DEFECT NO.	LOCATION	AREA	BREACH	PHOTOGRAPH	DEFECT DESCRIPTION
C 193	Level U4 lobby	Balcony – door threshold	Note.		<p>Paving pedestals installed over tiled surface.</p>  <p>HARPER OBSERVATION AND COMMENTS – NOT A DEFECT AS TILED SURFACE SUITABLE FOR PEDESTAL SYSTEM.</p>
C 194	Level U4 lobby	Balcony - handrail	See sections 8.5 and 8.26 of this report.		<p>Crack at line of possible DPC</p> <p>No visible DPC</p>  <p>HARPER OBSERVATION AND COMMENTS – NO EVIDENCE OF CRACK</p>

C-1	Door installation – Waterstop and weatherproof flashing	Scope of Remedial Works	Claim for Costs	Notes
	<p>The Author has observed that no water stop has been provided to the doors to all units.</p> <p>The Author noted that the defect was identified in Section 8.3 of the Construction Adviser (Giaouris) Report.</p> <p>The Author concurs with Giaouris view that the installation has not been carried out in accordance</p>	<p>Allow to:</p> <p>Apply following rectification methodology to each unit and door identified in Table C-1-1</p> <ol style="list-style-type: none"> 1. Provide site supervision. <p>Supervisor to coordinate access and facilitate the works throughout the</p>	<p>Co-ordination and Supervision - Refer

Reasoning – Waterstop Angle

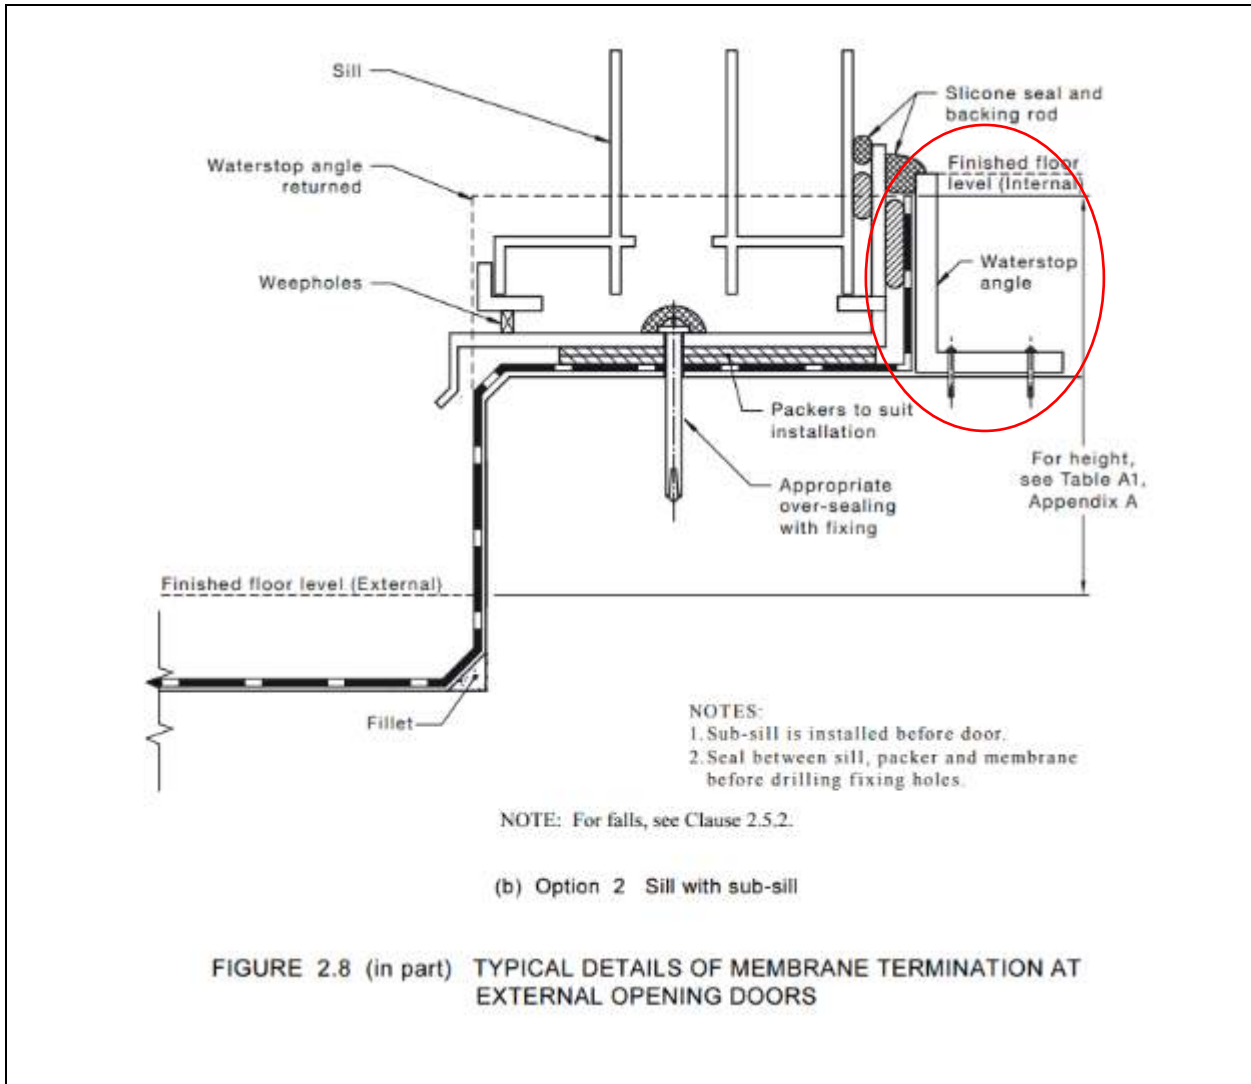
8.3.8 No waterstop angle has been installed to prevent moisture ingress as identified by AS4654.2:

8.3.9 Lack of waterstop angle to the rear side of sliding door threshold is allowing the moisture ingress and causing damage to the carpet's smooth edges.

Remediation

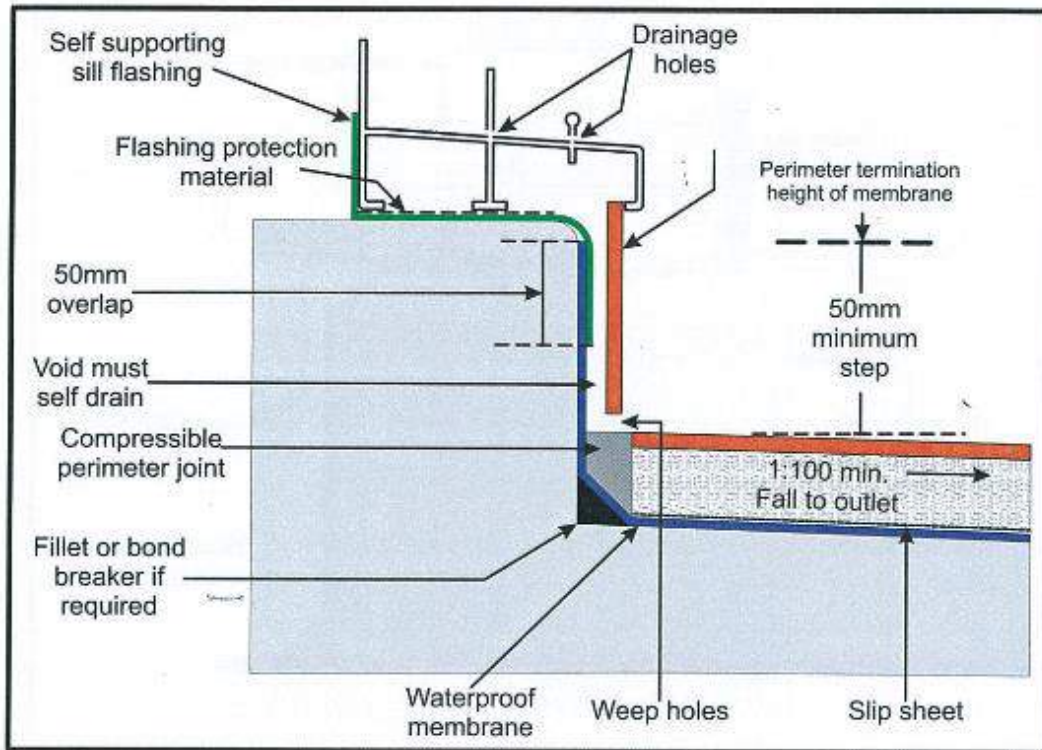
- 8.3.15 FP1.1 requires avoidance of the likelihood of damage to the building. Again, this has been breached as the carpet's smooth edge is deteriorating:

- 8.3.16 The windows and doors are not fit for purpose and have not been installed with due care and skill as required under section 18B of the HBA.
- 8.3.17 The building work is therefore considered defective as identified in section 18B of the HBA, due to:

- 1.1.1. Protect work area;
- 1.1.2. Remove sliding door suite;
- 1.1.3. Remove one row of tiles in front of sliding door;
- 1.1.4. Clean down existing waterproofing;
- 1.1.5. Reactivate waterproofing;
- 1.1.6. Install new waterproofing waterstop angle behind sliding door. Aluminium angle colour-matched to aluminium frame.
- 1.1.7. Install new waterproofing, angle and fillet to hob and waterstop as per the below diagram from the Master Builders' external waterproofing guide:

- 1.1.8. Reinstall sliding door suite;
- 1.1.9. Install tilings to site behind sliding door frame;
- 1.1.10. Install sealant to vertical and horizontal tile junction;
- 1.1.11. Install storm moulds to sliding door frame; and
- 1.1.12. Clean down the work area and demobilise.

C 47 – South facade (Mitchell Avenue), Hebel cladding

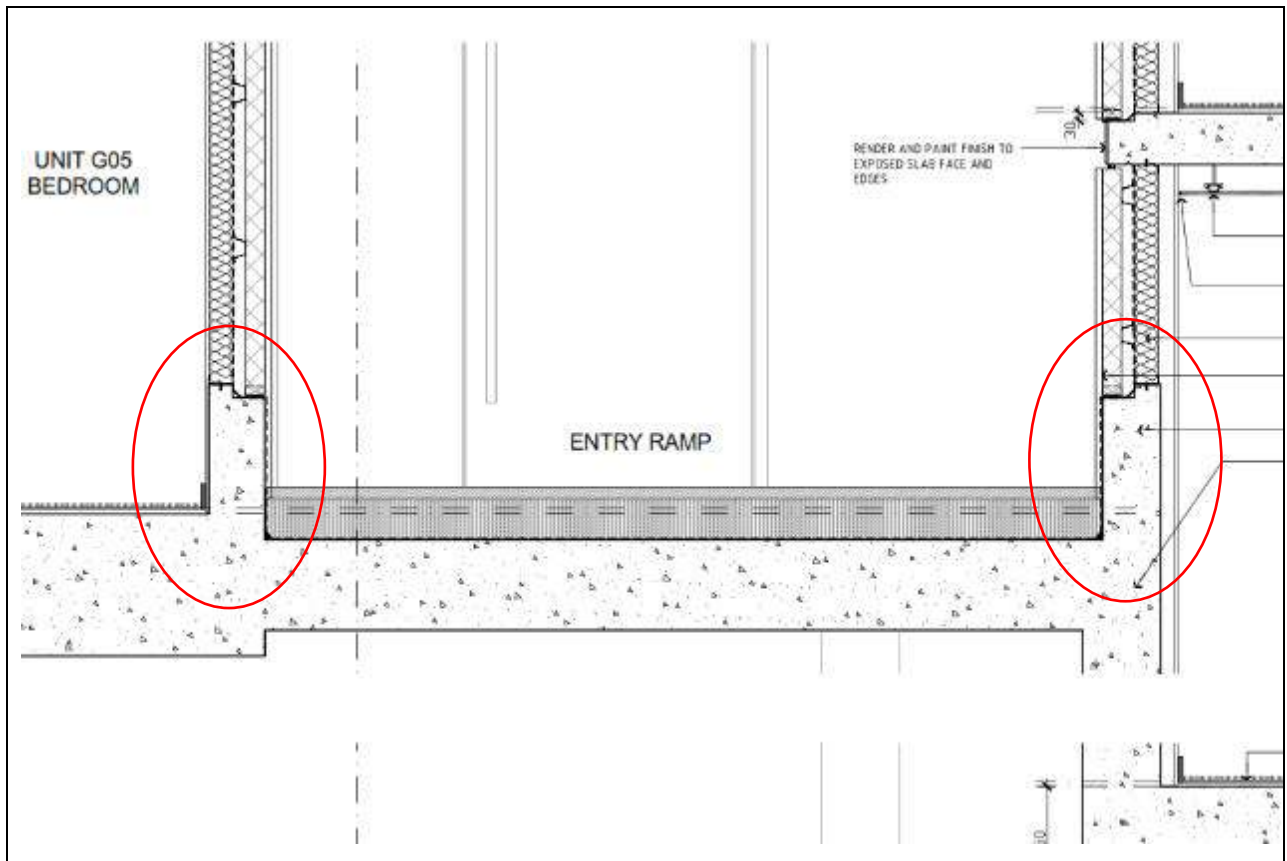
8.7.4 The external facades were first inspected on 3 of July 2020 when render works were under progress. It was identified that the FC cladding and Hebel cladding on the ground floor were installed below water level.

FC installed below water level.

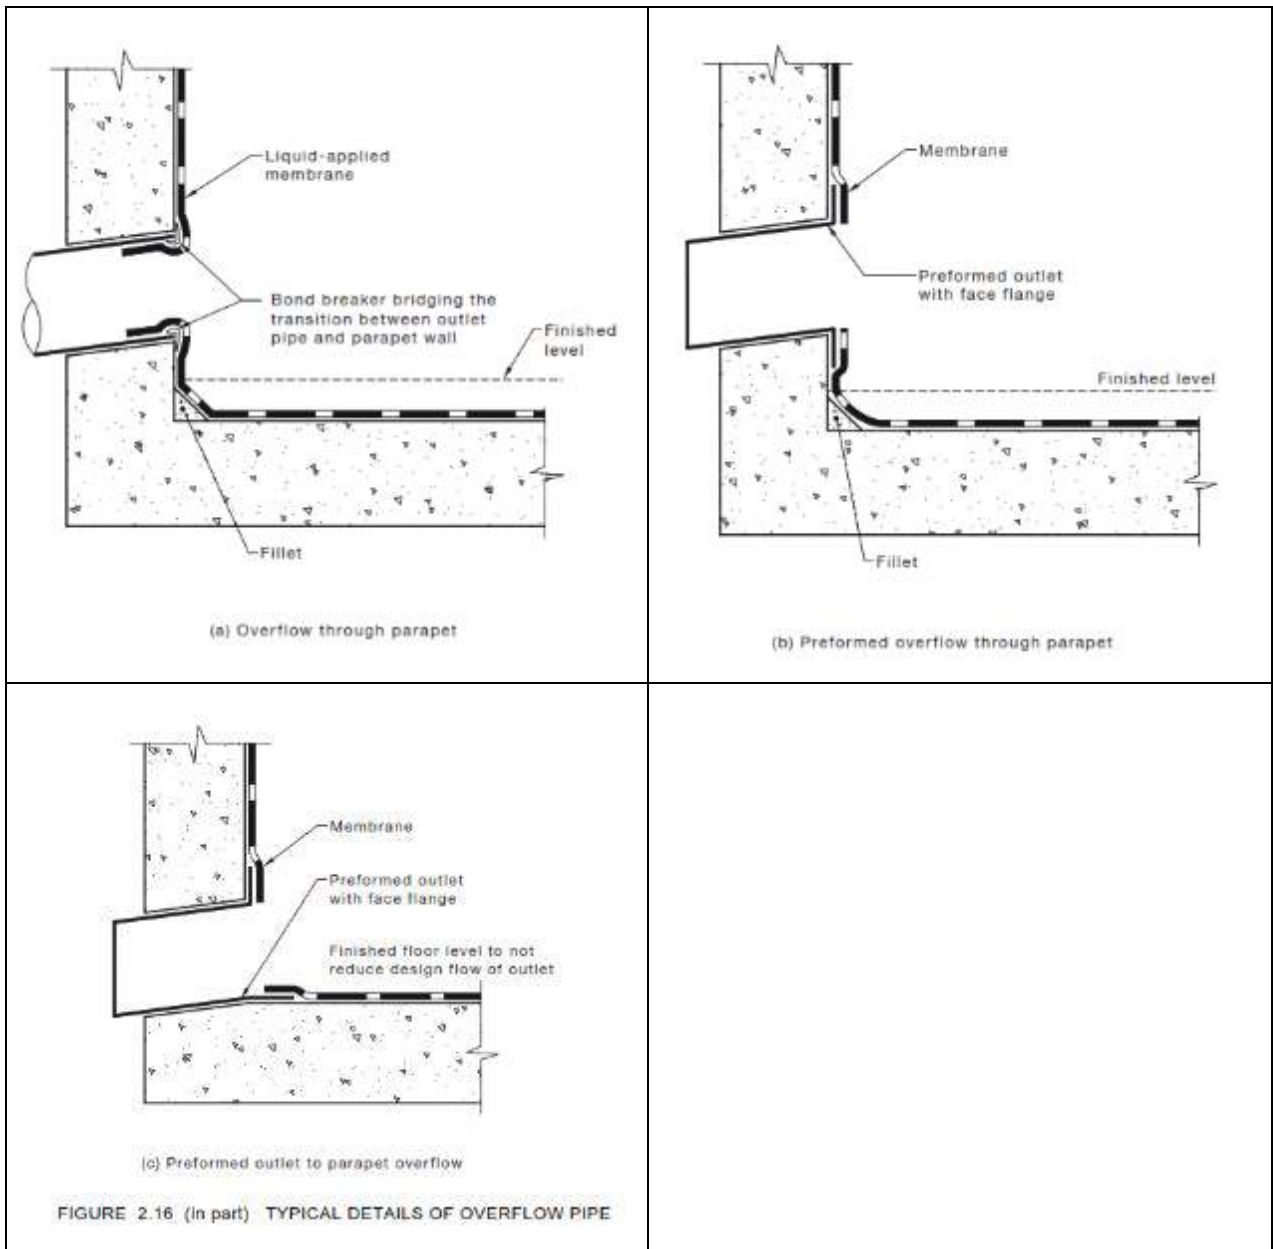
8.8.12 None of the inspected overflows had waterproofing detailed inside the overflow pipe or extended beyond the facade.

8.8.13 All of the overflow details provided in AS4654.2-2009 show the overflow pipe extending beyond the face of the facade (see extracts below):

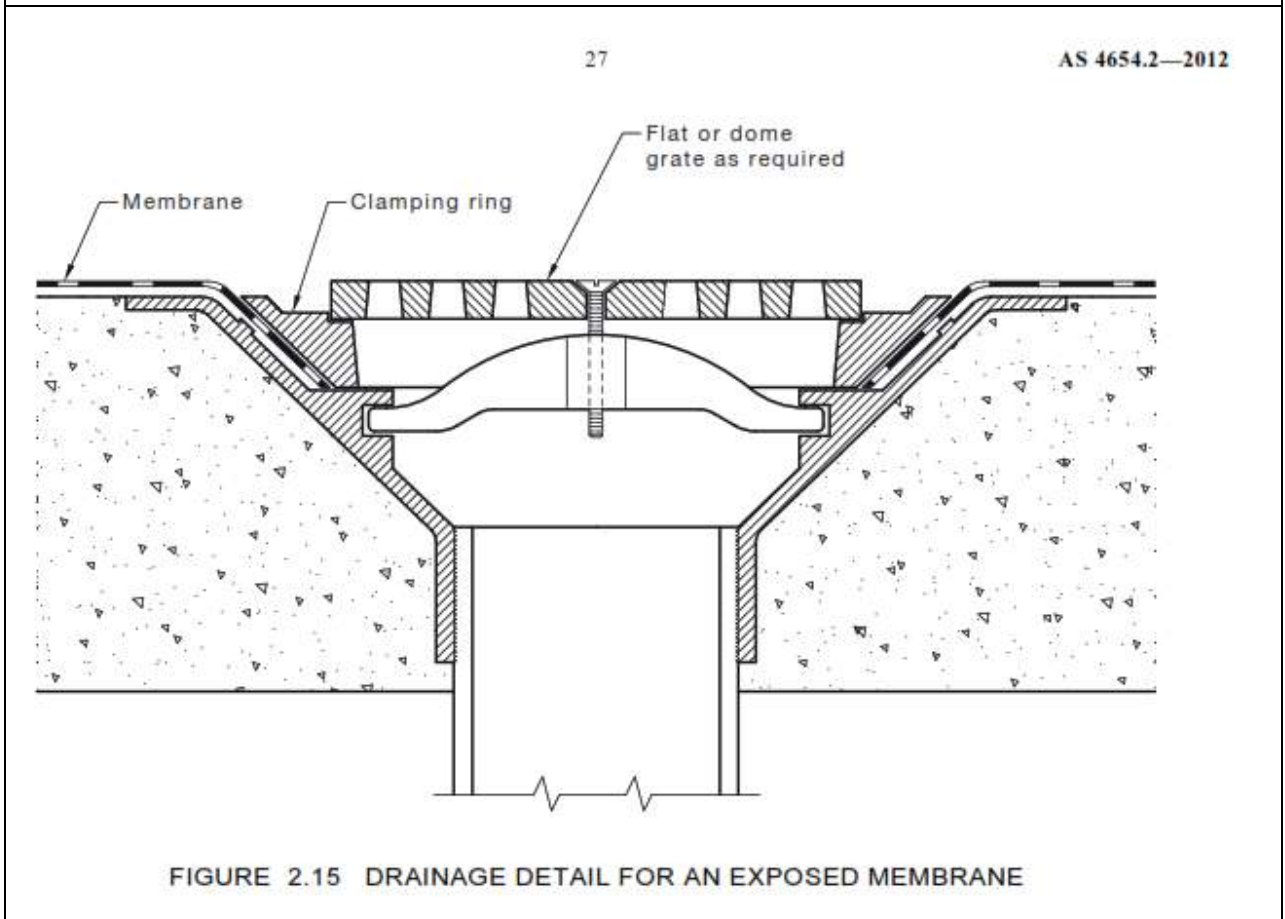
8.11.13 Membrane applied over the rough surface can tear and fail under pressure. It is susceptible to damage and installation of membrane over the rough substrate is in breach of AS 4654.2.

8.11.14 The waterproofing to the rooftops has not been turned down into the drains, as required by AS4654.2, or does it have a grate or drain (see details below):

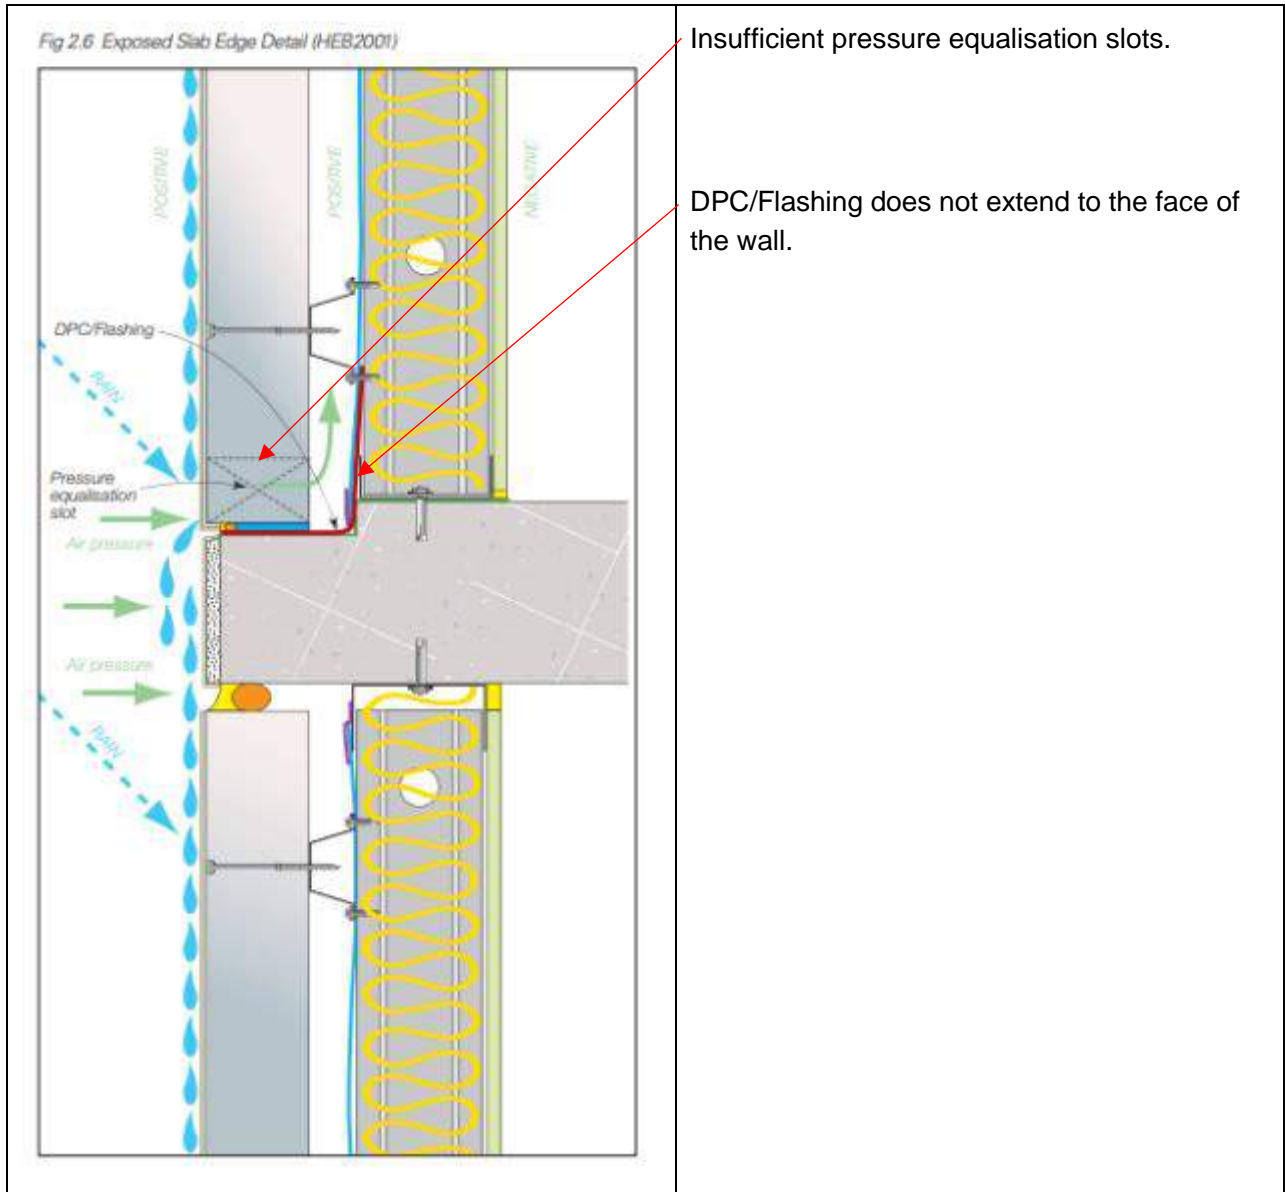
- 8.26.4 These pressure equalisation slots act to control pressure differences and allow for any moisture entering the cavity to drain.
- 8.26.5 Hebel has two facade systems: a visible slab edge type or a hidden slab edge type. Both systems require the pressure equalisation slots to be installed, the slab edge was visible at the installation to the Property.
- 8.26.6 Following is the manufacturer's detail, which identifies the elements that have not been installed:

Insufficient pressure equalisation slots.
